Alternative LTC Route Proposal  
(submitted by Robin Beard)

Please find attached my submission of an alternative route for the Lower Thames Crossing.

**Map 02 - My proposal for an alternative route**

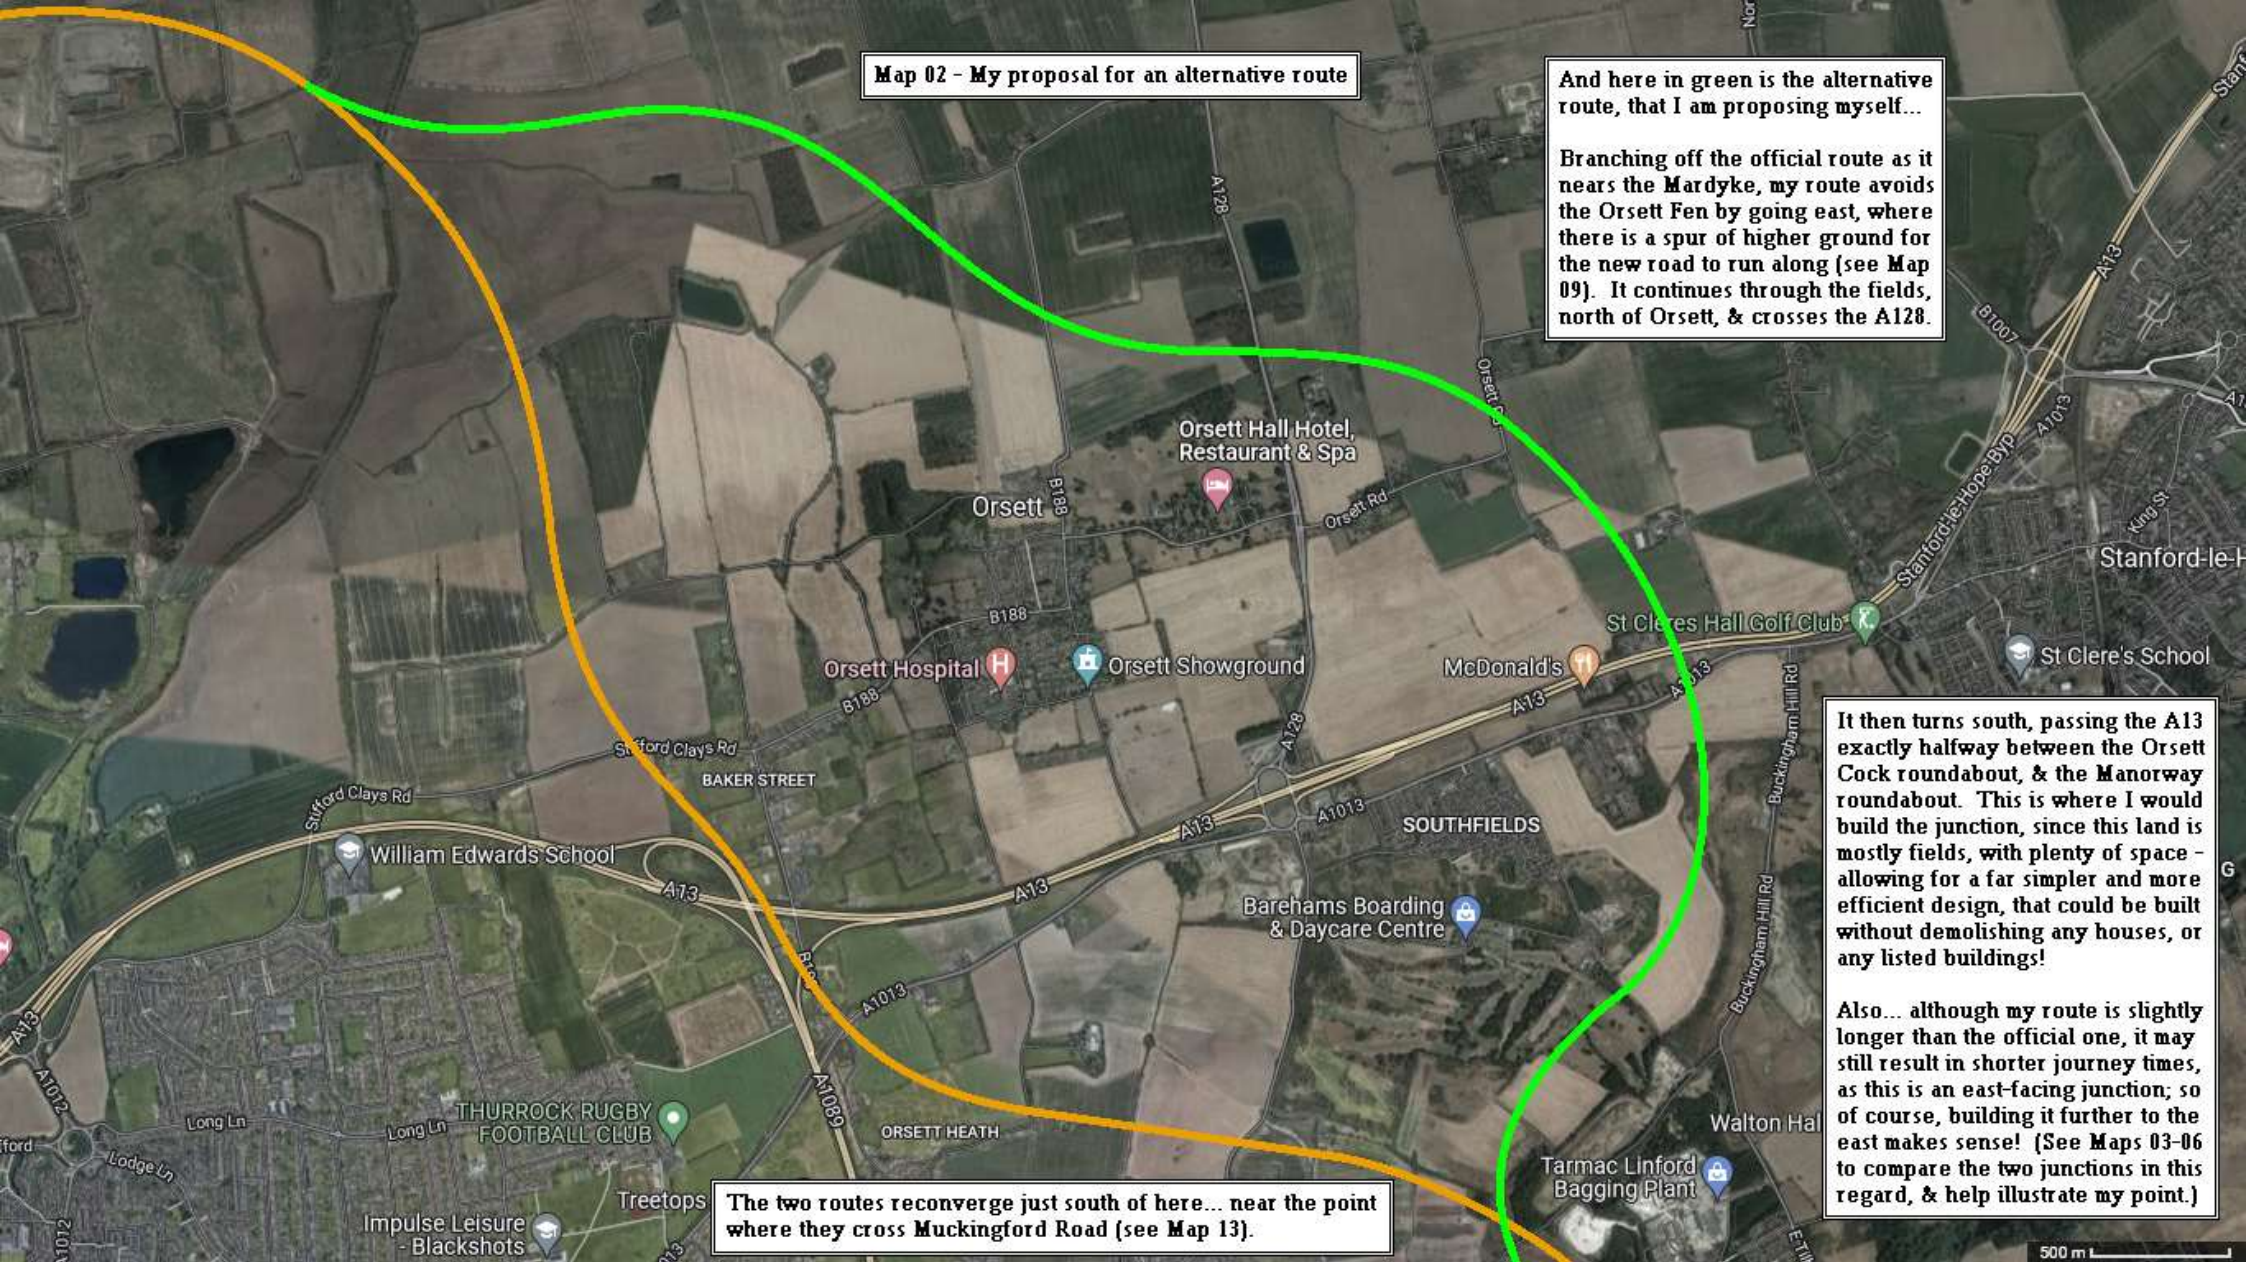
And here in green is the alternative route, that I am proposing myself...

Branching off the official route as it nears the **Mardyke**, my route avoids the Orsett Fen by going east, where there is a spur of higher ground for the new road to run along (see **Map 09**). It continues through the fields, north of Orsett, & crosses the A128.

It then turns south, passing the A13 exactly halfway between the Orsett Cock roundabout, & the Manorway roundabout. This is where I would build the junction, since this land is mostly fields, with plenty of space - allowing for a far simpler and more efficient design, that could be built without demolishing any houses, or any listed buildings!

Also... although my route is slightly longer than the official one, it may still result in shorter journey times, as this is an east-facing junction; so of course, building it further to the east makes sense! (See **Maps 03-06** to compare the two junctions in this regard, & help illustrate my point.)

Map 04 - A13 Westbound connections to LTC

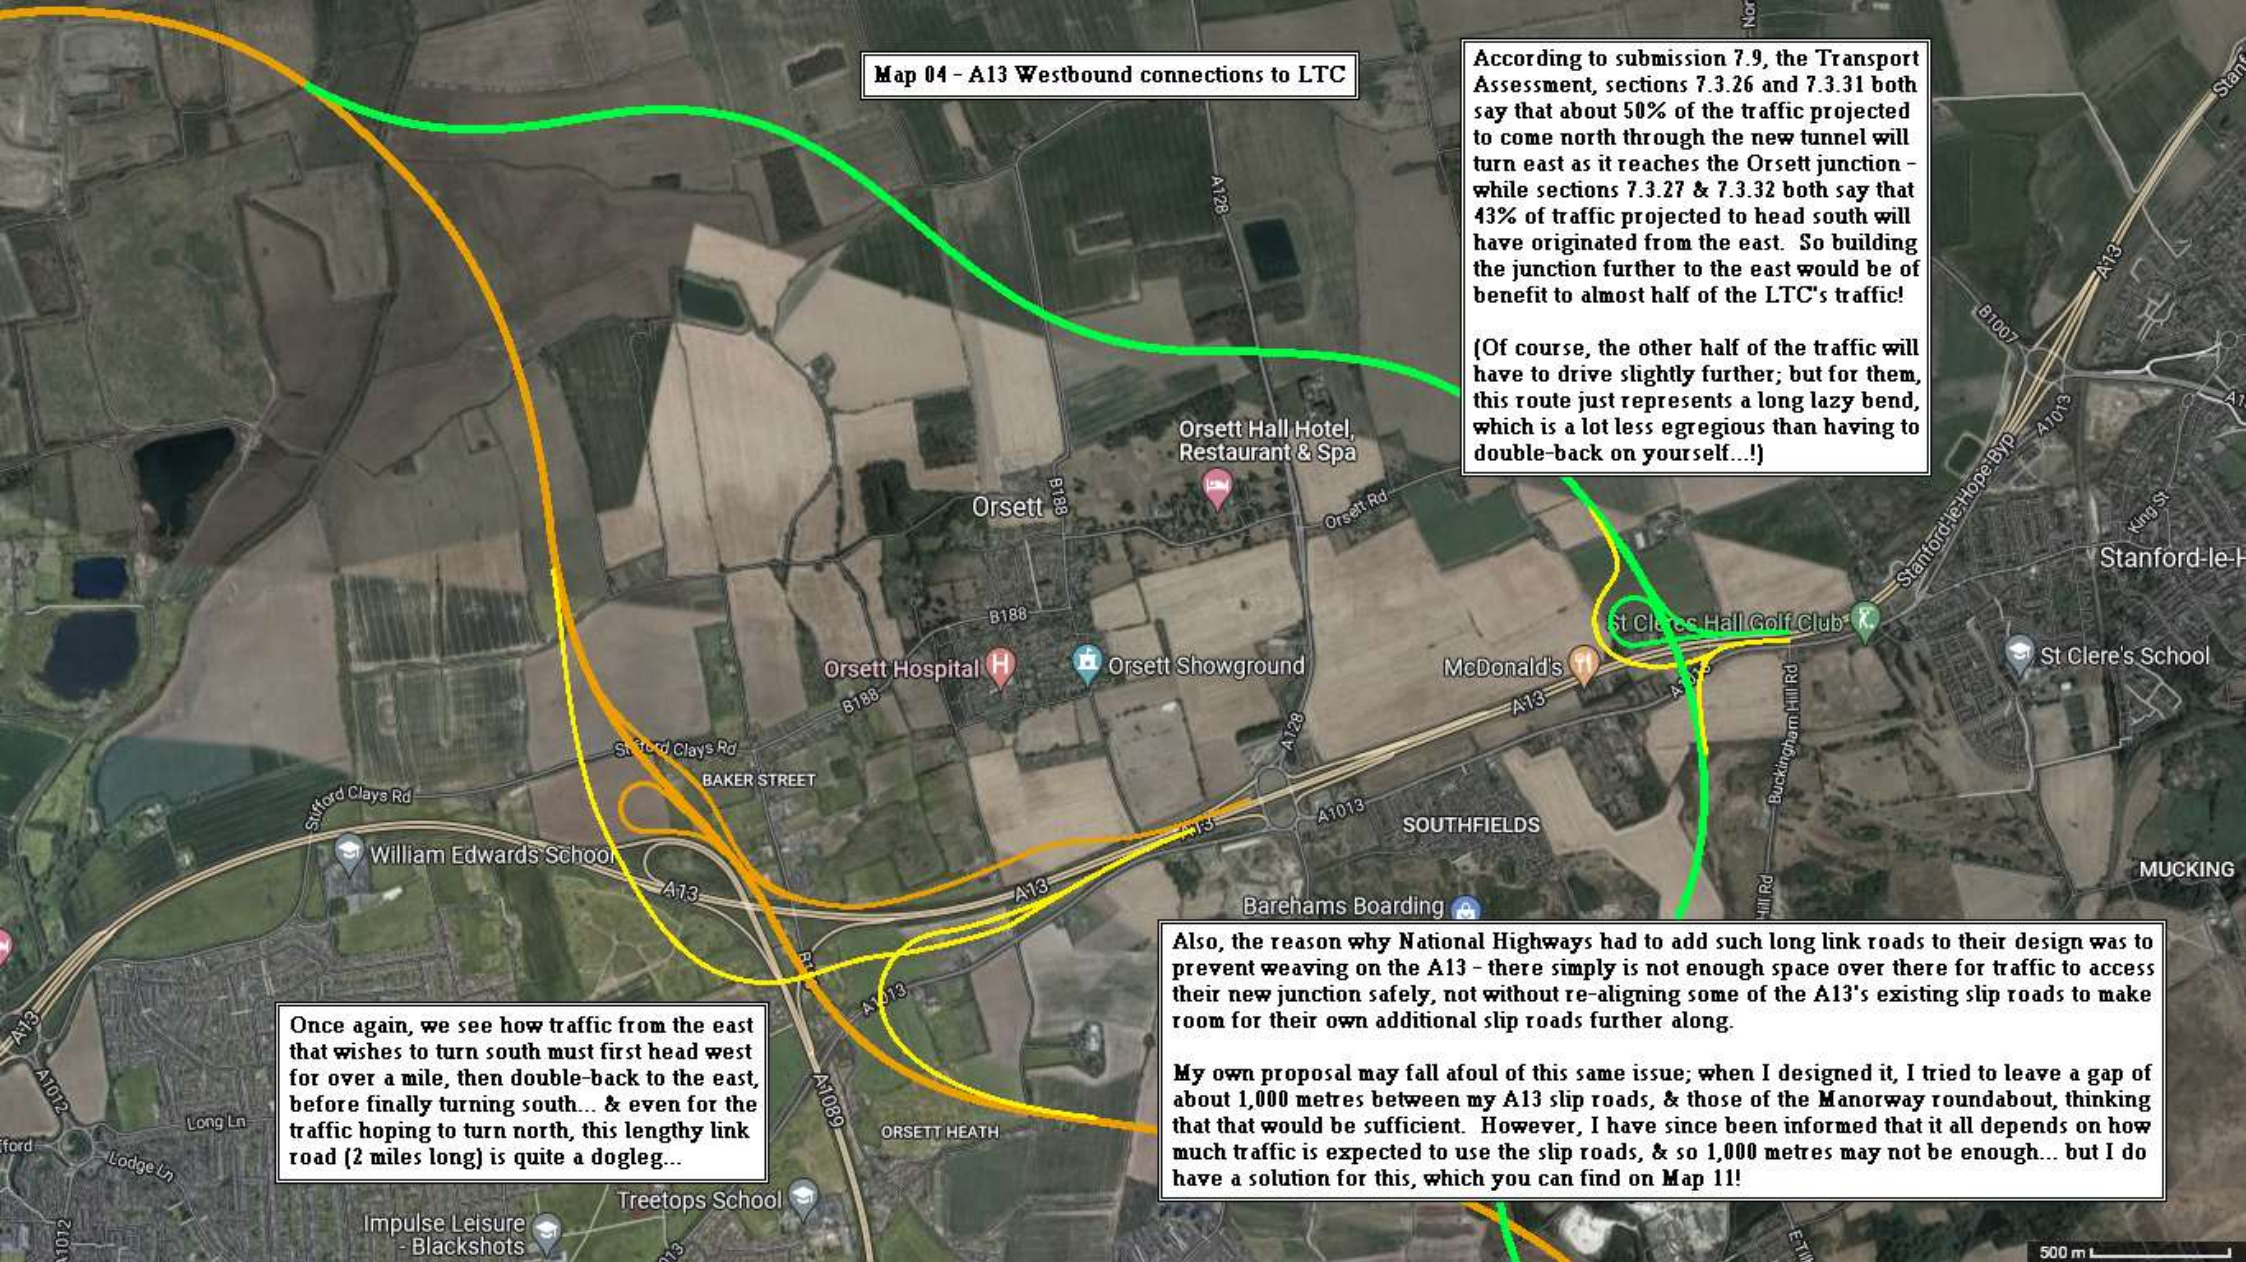
According to submission 7.9, the Transport Assessment, sections 7.3.26 and 7.3.31 both say that about 50% of the traffic projected to come north through the new tunnel will turn east as it reaches the Orsett junction - while sections 7.3.27 & 7.3.32 both say that 43% of traffic projected to head south will have originated from the east. So building the junction further to the east would be of benefit to almost half of the LTC's traffic!

Once again, we see how traffic from the east that wishes to turn south must first head west for over a mile, then double-back to the east, before finally turning south... & even for the traffic hoping to turn north, this lengthy link road (2 miles long) is quite a dogleg...

Also, the reason why National Highways had to add such long link roads to their design was to prevent weaving on the A13 - there simply is not enough space over there for traffic to access their new junction safely, not without re-aligning some of the A13's existing slip roads to make room for their own additional slip roads further along.

My own proposal may fall afoul of this same issue; when I designed it, I tried to leave a gap of about 1,000 metres between my A13 slip roads, & those of the Manorway roundabout, thinking that that would be sufficient. However, I have since been informed that it all depends on how much traffic is expected to use the slip roads, & so 1,000 metres may not be enough... but I do have a solution for this, which you can find on Map 11!

Map 05 - LTC connections to A1089 Southbound

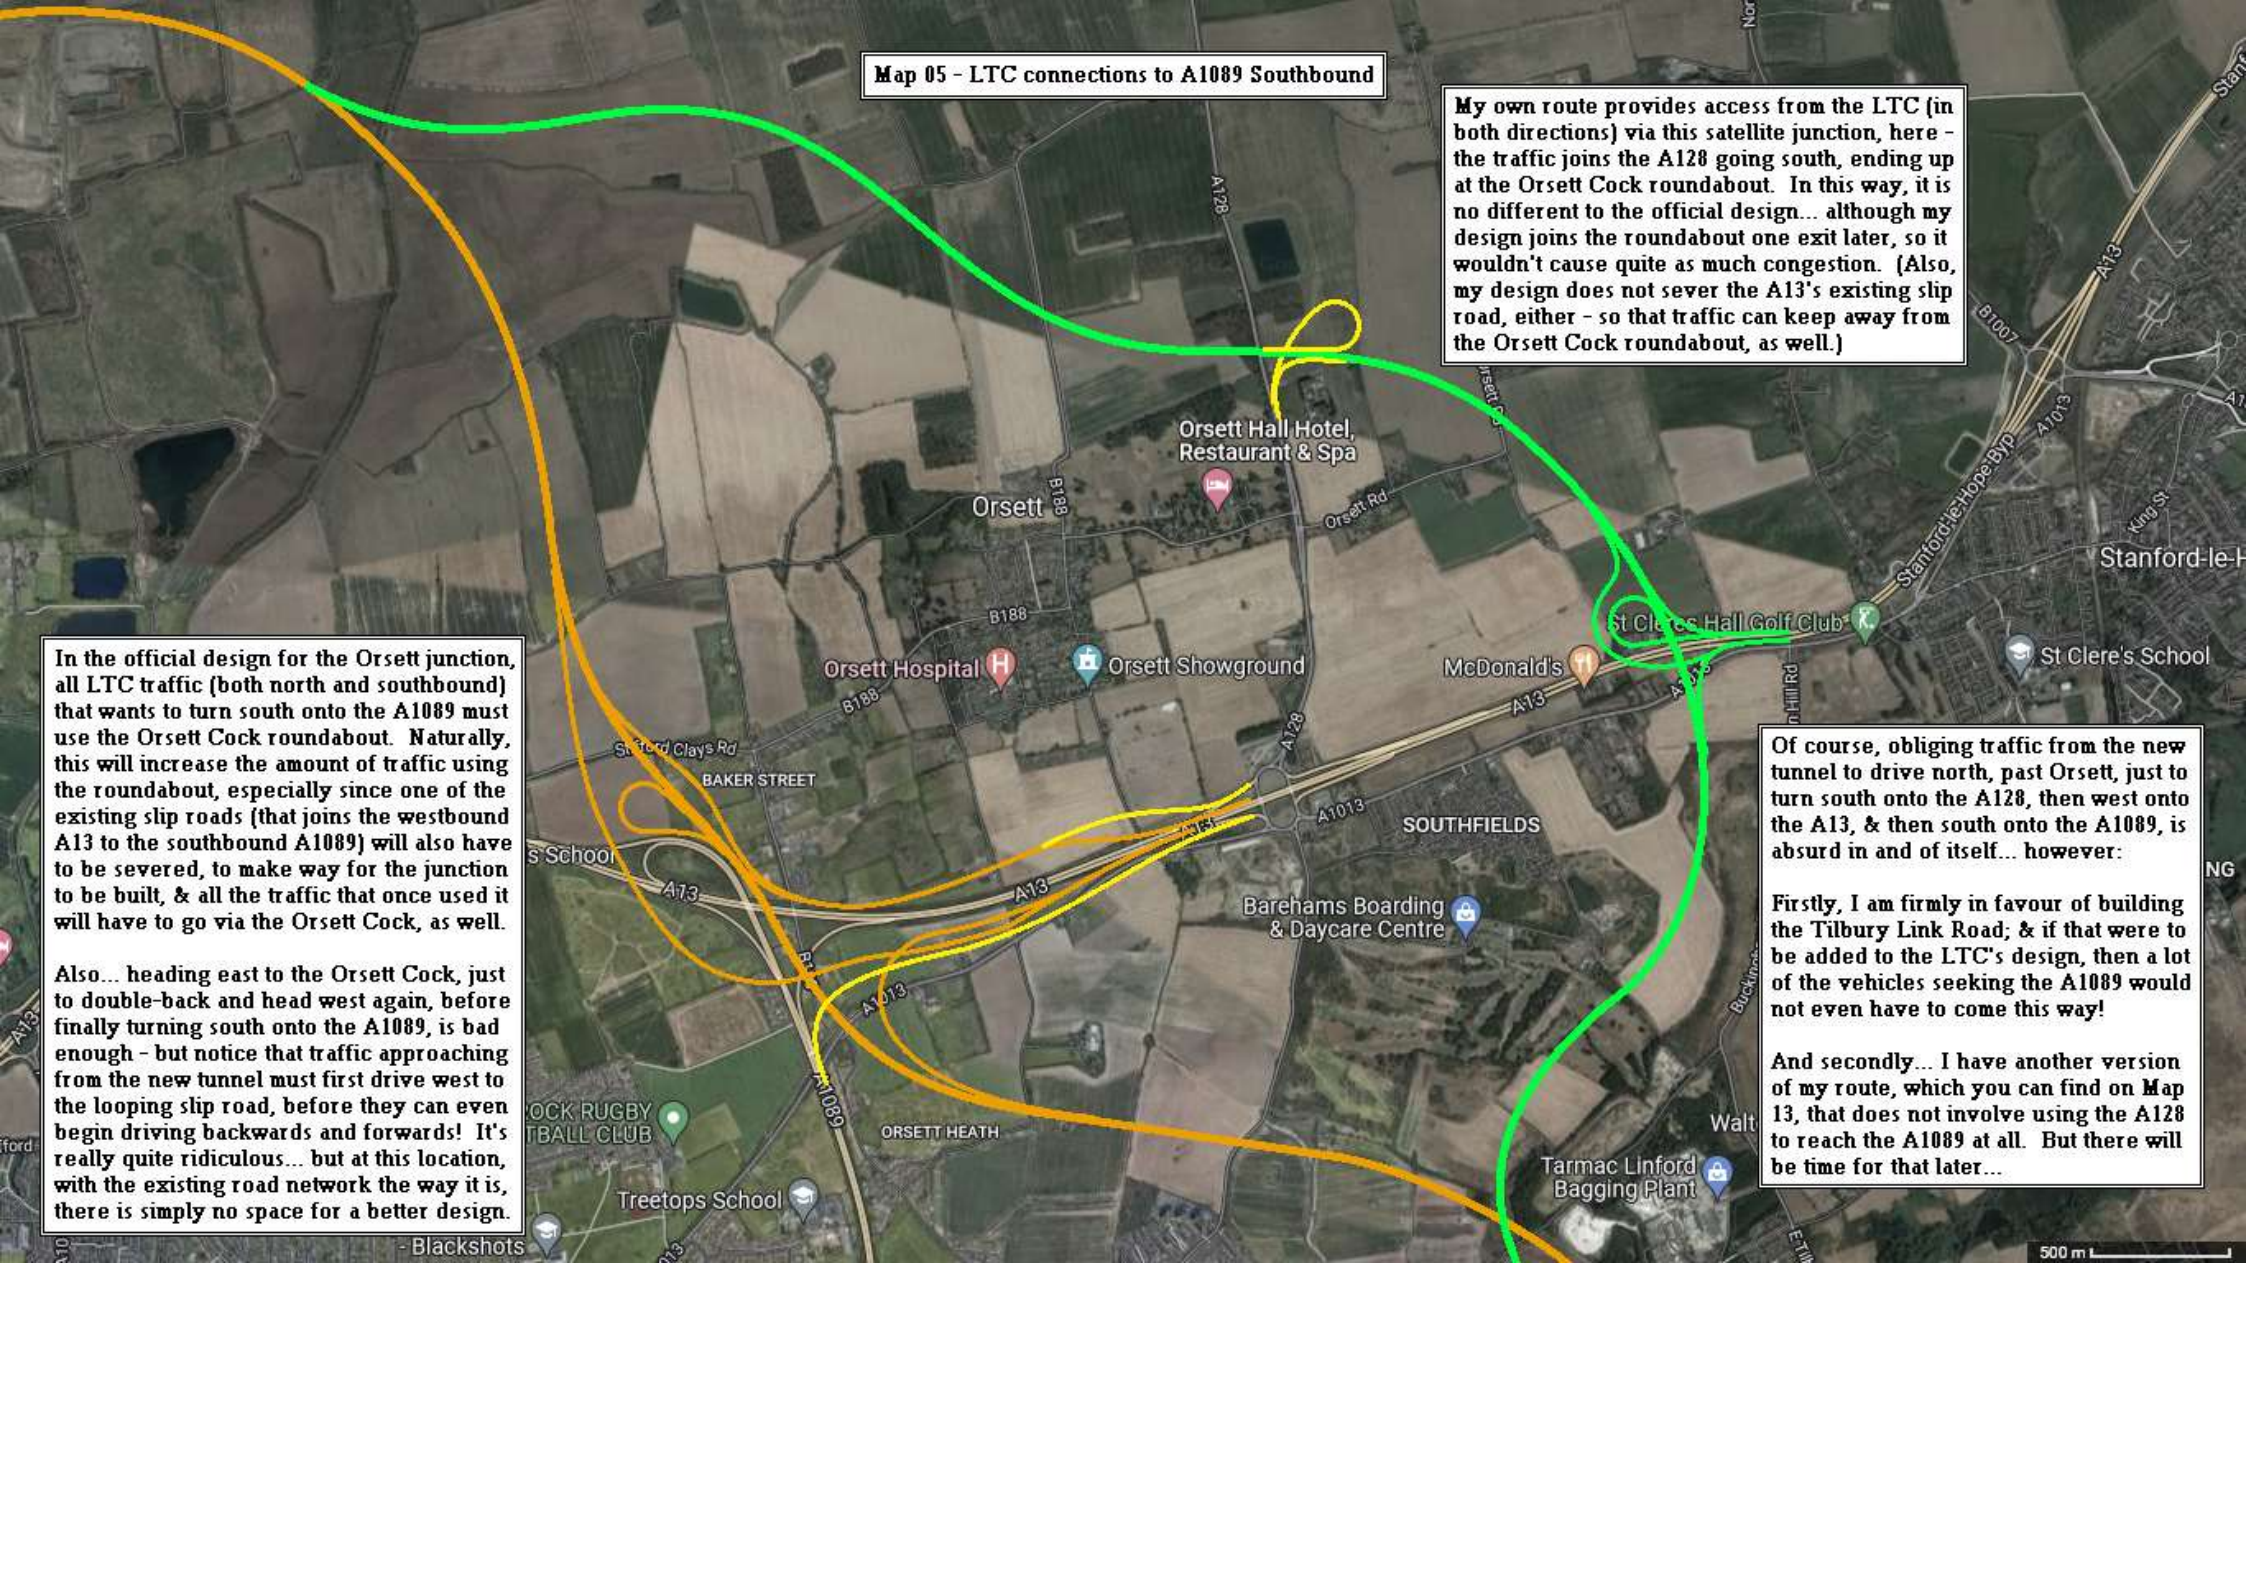
My own route provides access from the LTC (in both directions) via this satellite junction, here - the traffic joins the A128 going south, ending up at the Orsett Cock roundabout. In this way, it is no different to the official design... although my design joins the roundabout one exit later, so it wouldn't cause quite as much congestion. (Also, my design does not sever the A13's existing slip road, either - so that traffic can keep away from the Orsett Cock roundabout, as well.)

In the official design for the Orsett junction, all LTC traffic (both north and southbound) that wants to turn south onto the A1089 must use the Orsett Cock roundabout. Naturally, this will increase the amount of traffic using the roundabout, especially since one of the existing slip roads (that joins the westbound A13 to the southbound A1089) will also have to be severed, to make way for the junction to be built, & all the traffic that once used it will have to go via the Orsett Cock, as well.

Also... heading east to the Orsett Cock, just to double-back and head west again, before finally turning south onto the A1089, is bad enough - but notice that traffic approaching from the new tunnel must first drive west to the looping slip road, before they can even begin driving backwards and forwards! It's really quite ridiculous... but at this location, with the existing road network the way it is, there is simply no space for a better design.
